JUNEAU GLACIER HIGHWAY / PROJECT NO. 69845  
 POINT LOUISA TO TEE HARBOR

JUNEAU GLACIER HIGHWAY  
PROJECT NO. 69845  
POINT LOUISA TO TEE HARBOR

JUNEAU GLACIER HIGHWAY / PROJECT NO. 69845  
POINT LOUISA TO TEE HARBOR  
PLAN & PROFILE

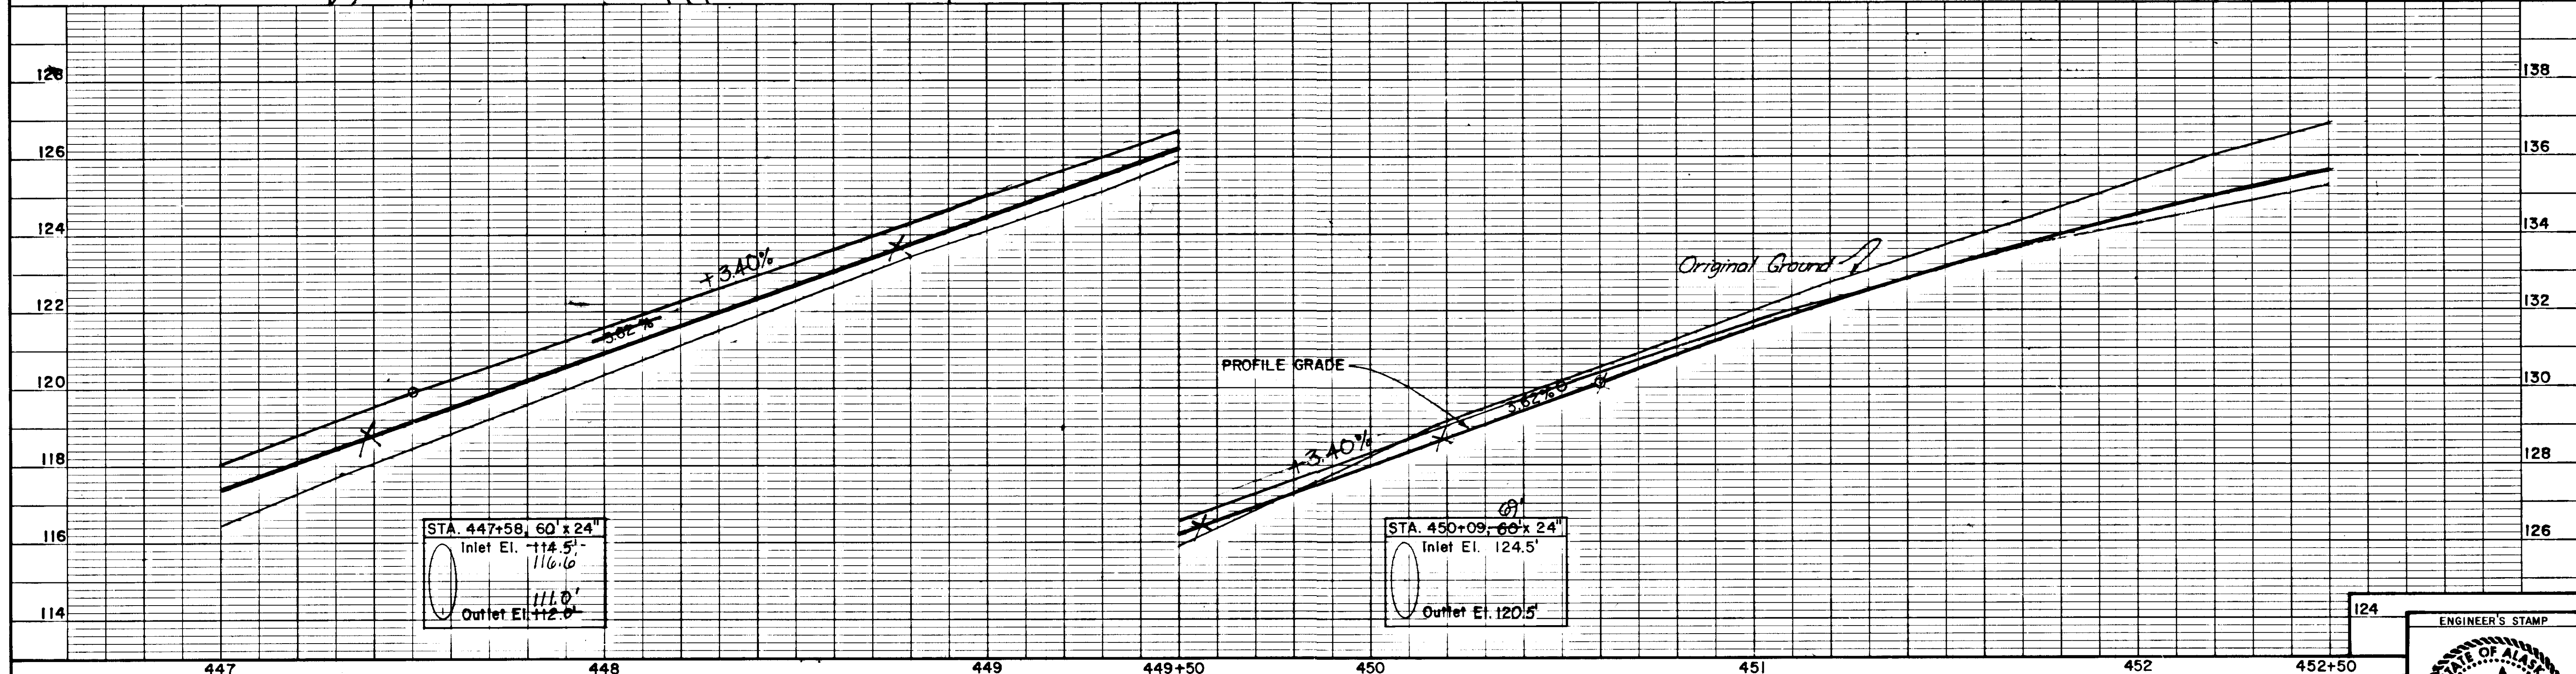
| DATE    | DESCRIPTION OF CHANGE                     |
|---------|-------------------------------------------|
| 3-30-96 | Correct Slope Limits Sta 445+00 to 445+50 |
